**Air Quality and Permit
Review:**
Calderdale Valley Skip
Hire Small Waste
Incineration Plant

November 2021

A review of the Environmental Permit application and associated air quality technical information for the Calder Valley Skip Hire (CVSH) Small Waste Incinerator Plant (SWIP) has been undertaken.

Figure 1: Visual depiction of the ‘knee-point’ on a stack height assessment graph

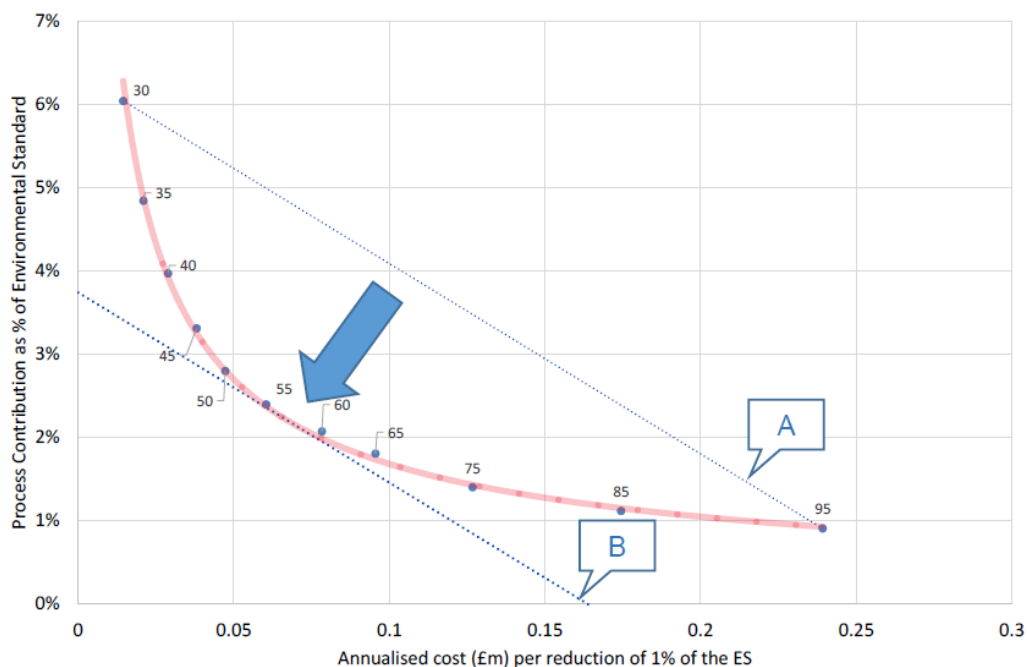
- 3.17 Appendix D of the 2019 Additional Air Quality Assessment details how the requirement for a 12 m stack was determined. However, this analysis (in Graph D1) shows that the air quality impacts would be appreciably smaller if a taller stack were chosen, even when the stack is increased by just a few metres. A cursory examination of these graphs shows that 12 m does not represent a point at which further height increases have diminishing returns in terms of reduction in the predicted ground level concentration. In practice, the justification for a 12 m stack appears to be that most impacts can, with this stack height, be described as '*negligible*'. However, as identified previously, there are valid reasons to suggest impacts could be greater than negligible.

- 3.18 The Environment Agency has produced internal draft stack height assessment guidance with a particular emphasis on incineration plants⁸. This guidance has previously been provided by the Environment Agency to the reviewers as an example of a methodology it would accept for determining the minimum required stack height for incineration plants.
- 3.19 The guidance clarifies that the stack height, according with the principles of Best Available Technique (BAT), can be defined as the ‘knee-point’ of a graph plotting the reduction in process contribution as a function of increasing stack height (the method actually uses stack costs, but stack height is often used as a proxy for cost). Figure 1 provides an example figure depicting the knee-point (blue arrow) from this guidance document.

- 3.20 The Environment Agency guidance clarifies that where an impact is defined as ‘insignificant’ for a particular stack height, i.e., where long-term process contributions are less than 1% of the relevant AQS, or where short-term process contributions are less than 10% of the AQS, further increases in stack height are not necessary as it follows that any further reduction in impact will also be insignificant.
- 3.21 Hence, it is possible for the BAT stack height to occur before the knee-point. Where this is the case, the shorter stack height would be considered BAT. For this particular plant, it is evident that the selected stack height of 12 m occurs before the knee-point. However, process contributions at 12 m

for several pollutants cannot be defined as insignificant⁹. Consequently, the applicant has failed to demonstrate that a stack height corresponding to the principle of BAT¹⁰ has been selected, and further justification should be provided.
